Docket Item #14 A&B

**Rezoning #2013-0002**

**Development Special Use Permit # 2013-0004**

**5801 & 5815 Duke Street – Landmark Mall**

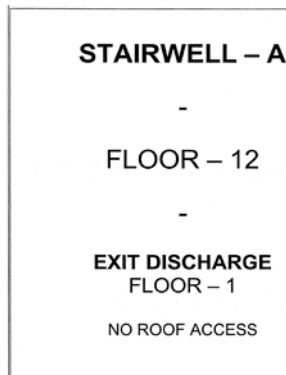
- C - 9. Per the requirements of Title 4, Chapter 2, Article B, Section 4-2-21, Appendix A, Section A 106(6), Figure A 106.1 Minimum Standards for Emergency Vehicle Access: provide a total turning radius of 25 feet to the satisfaction of Directors of T&ES and Office of Building and Fire Code Administration and show turning movements of standard vehicles in the parking lot as per the latest AASHTO vehicular guidelines. (T&ES)

- **Turning Radius – Wall to Wall = 54.98 feet + / - 2 feet**  
**Curb to Curb = 51.33 feet + / - 2 feet**  
**Inside turning radius = 37.73 feet + / - 2 feet**
- **Overall Length – 47' – 4 1/2"**
- **Overall Width – 98"**
- **Wheel Bases from front axle to both rear axles – 240"**
- **Tandem axle spacing – 56" CL of axle to CL of axle**

- **Gross Weight – As built with no equipment or water gross weight = 66,000#**
- **Angle of Approach – 13 Degrees**
- **Angle of Departure – 11 degrees**
- **Ramp Break Over – Break over angle is 9°**

**Applicant has provided.**
